05/31/2019
CAL WS 49-001

Subject: ATD Inlet Pipe Bellows Assembly

**Models Affected: Specific Western Star 4900 Low Max Car Hauler
Model Year 2017 through 2020 vehicles manufactured from January 1, 2016 to June 31, 2019.**

ATD Inlet Pipe Bellows Assembly Replacement

Fig. 1, Bellows Assembly

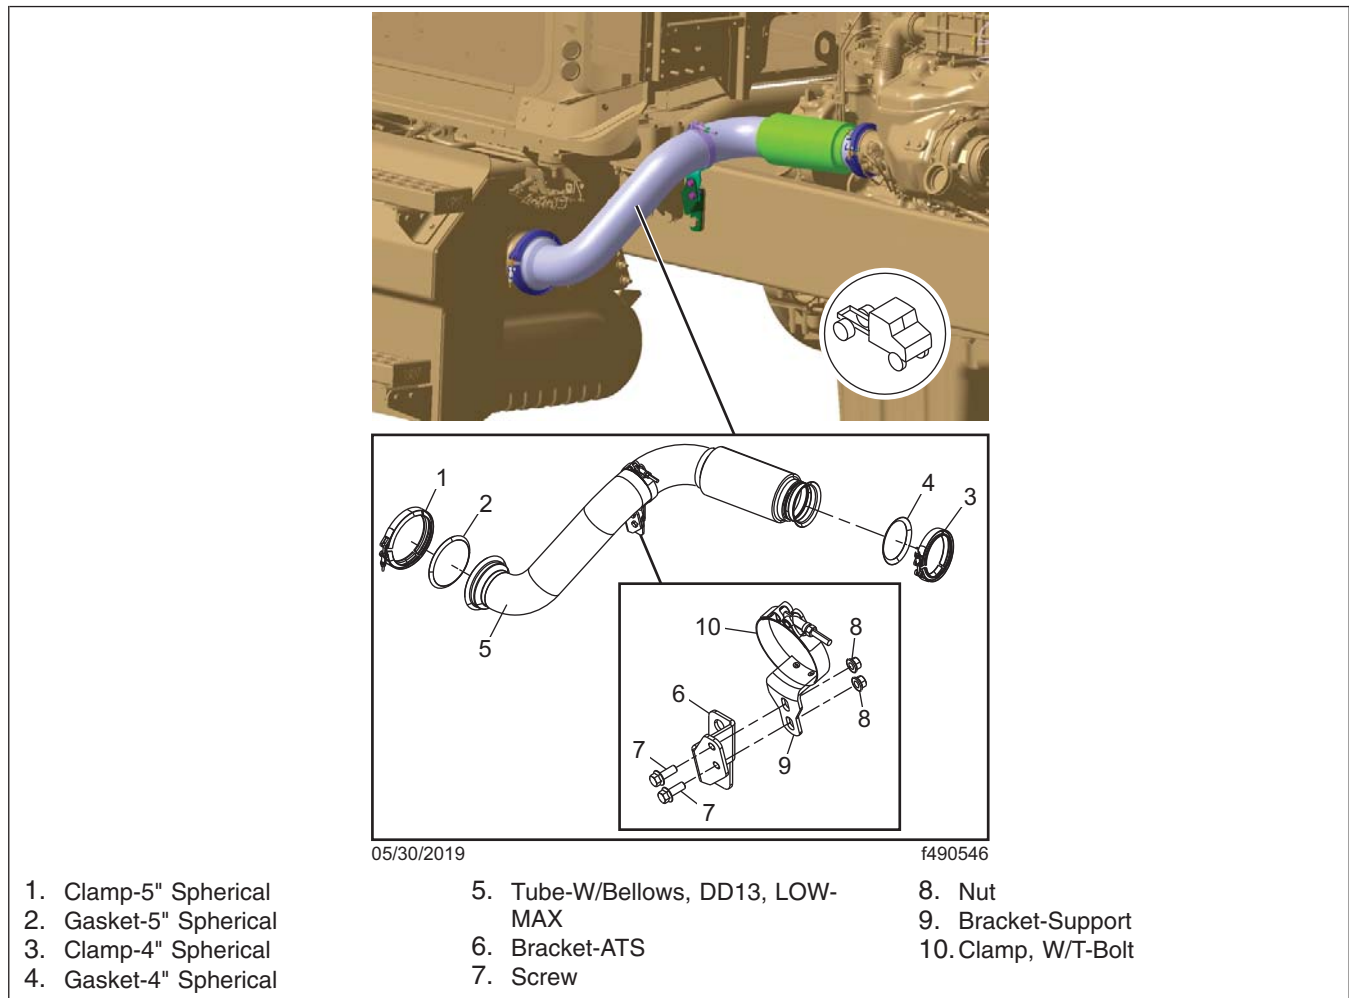
Some Western Star Low Max 4900 Car Hauler applications with DD13 GHG17 engines containing bellows pipe part number 04-32700-000, may experience high failure rates due to cracking at the ATD flange. Western Star will be providing a modified pipe to mitigate the cracking issue. This pipe modification will be done locally under the supervision of Transwest Truck, an authorized dealer for Western Star, and/or Western Star Management.

10. Remove the bellows and ATD inlet pipe as an assembly. See [Fig. 1](#).

11. Position the new bellows and the ATD inlet pipe assembly on the vehicle.
12. Install the new spherical clamp and gasket at the ATD inlet. Do not tighten at this time.

13. Install the new spherical clamp and gasket at the bellows-to-turbocharger outlet pipe connection. Do not tighten at this time.
14. On DD13 engines only, install the ATD inlet pipe support bracket clamp. Do not tighten at this time.

15. Using a straight edge, align the bellows, the ATD inlet pipe, and the turbocharger outlet pipe. Check from at least two positions about 90 degrees apart. All three components should form a straight line through the connections.
